Turbo HD DVR V3.5.40 Build171110 Release Notes (2017-11-29)

| | Firmware Version: | V3.5.40 Build171110 |

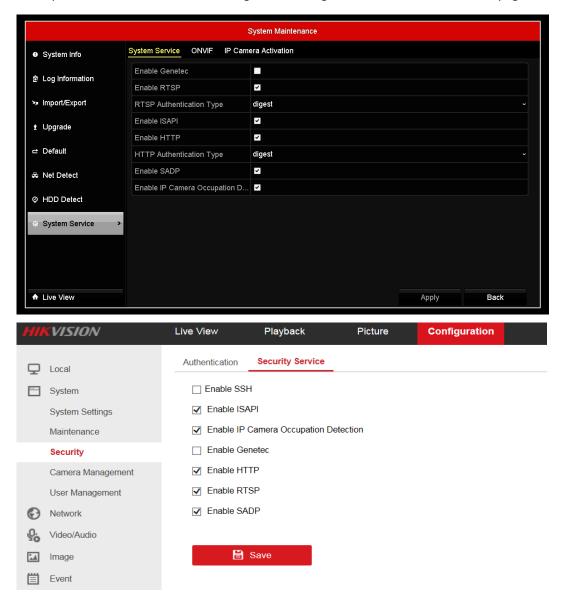
- HQ series DVR newly support 4MP TVI and AHD signal input, HU series DVR newly support 4MP AHD signal input.
- 2. HU series DVR support recording 5MP@12fps, 4MP@15fps,3MP@18fps, 1080p@real-time. Sub stream recording WD1@real-time.
- iii. HQHI-K newly support 4MP lite mode:
 - 4MP lite technology is the same with 1080P lite. Live view: 4MP lite@ full frame, recording: 4MP lite (1280*1440) @15fps;
 - 2. Support all channels 4MP cameras access; when connecting 3MP cameras, only channel 1-4

support while others not.

3. The max recording frame rate of 4MP lite is always 15 fps, no matter whether 1080P lite mode is enabled or not.

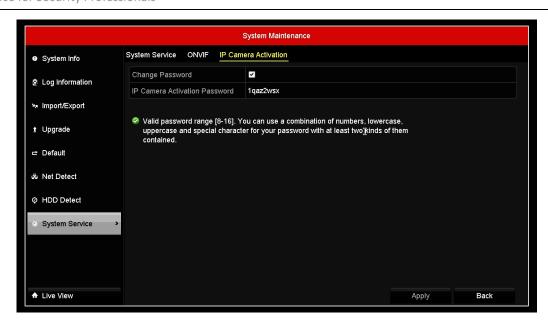
Some protocols and service is now configurable, configurations of local GUI and web page are as below:

- 1. Delete PSIA server/client protocol;
- 2. User can enable or disable Genetec service;
- 3. User can enable or disable ONVIF protocol, this function is only available when DVR is used as server;
- 4. User can enable or disable ISAPI protocol;
- 5. User can disable/enable HTTP protocol and choose HTTP authentication type between digest and

digest &basic (only valid for third-party integration, Hikvision web uses session authentication);

- User can disable/enable SADP protocol;
- 7. User can disable/enable IP camera occupation detection, when this function is enabled, DVR will detect whether IP camera is already connected to other device/client;

Modified Functions

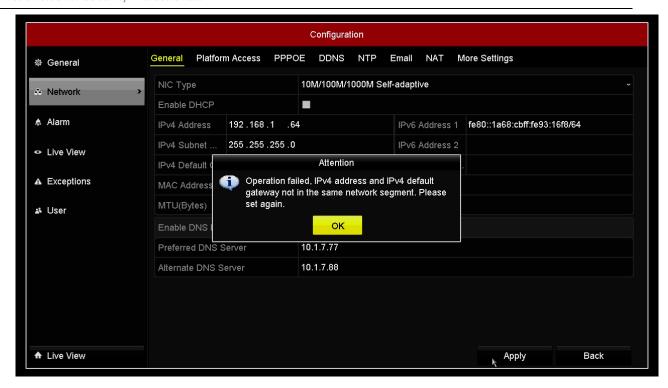
i. Cancel the restriction that gateway IP and IP address can't be set in the different network segment to meet customers' requirement.
